## **STATEMENT OF CEC STAFF APPROVAL OF POST- CERTIFICATION CHANGE HUBMOLDT BAY GENERATING STATION (06-AFC-07C)**

**Humboldt Bay generating station (06-AFC-07C)**  
**Petition to Amend for Operating in Low Load and Black Start Modes**  
**Air Quality, Public Health, and Greenhouse Gases**  
**Tao Jiang, Ph.D., P.E.**

### Environmental Justice – Figure 1

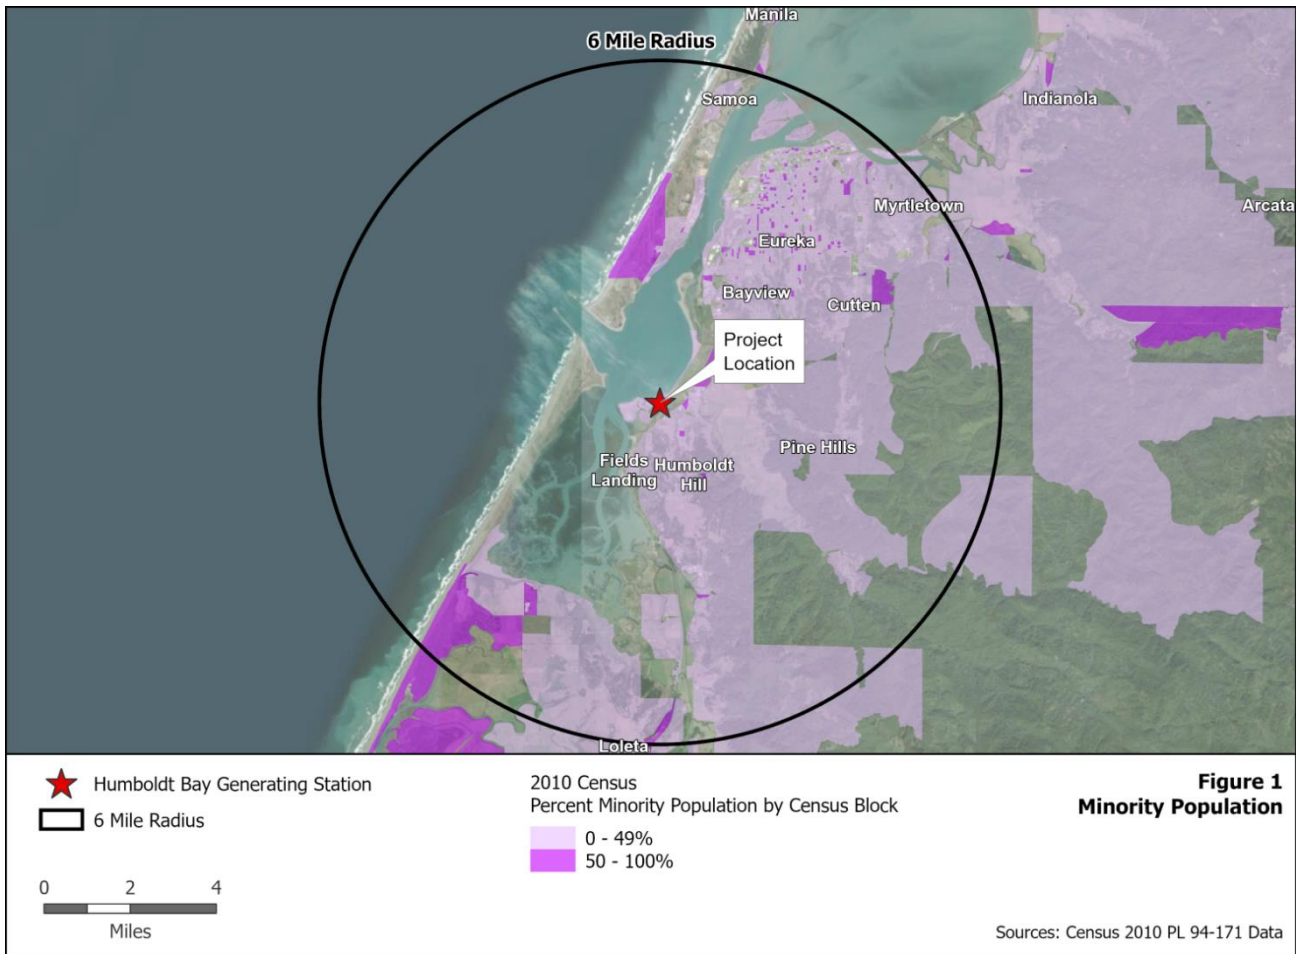
**Environmental Justice – Figure 1** shows the 2010 census blocks in the 6-mile radius of the HBGS with a minority population greater than or equal to 50 percent. The population in these census blocks represents an environmental justice (EJ) population based on race and ethnicity as defined in the United States Environmental Protection Agency's *Guidance on Considering Environmental Justice During the Development of Regulatory Actions*. Staff conservatively obtains demographic data within a 6-mile radius around a project site based on the parameters for dispersion modeling used in staff's air quality analysis. Air quality impacts are generally the type of project impacts that extend the furthest from a project site. Beyond a 6-mile radius, air emissions have either settled out of the air column or mixed with surrounding air to the extent that potential impacts are less than significant. The area of potential impacts would not extend this far from the project site for most other technical areas included in staff's EJ analysis.

## Environmental Justice – Figure 2

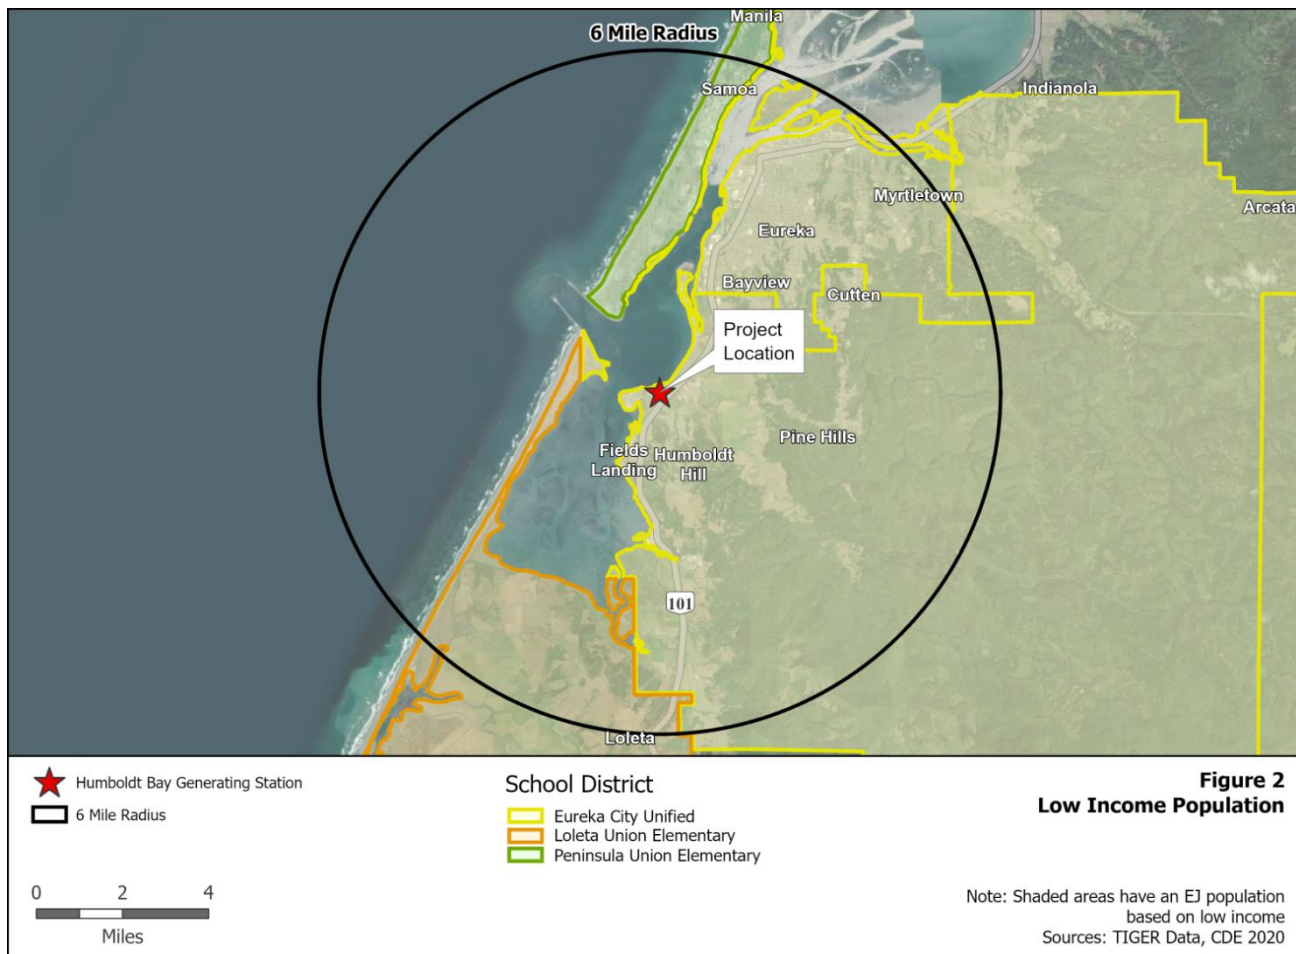
**Environmental Justice – Figure 2** shows where the boundaries of the school district are in relation to the 6-mile radius around the HBGS site.
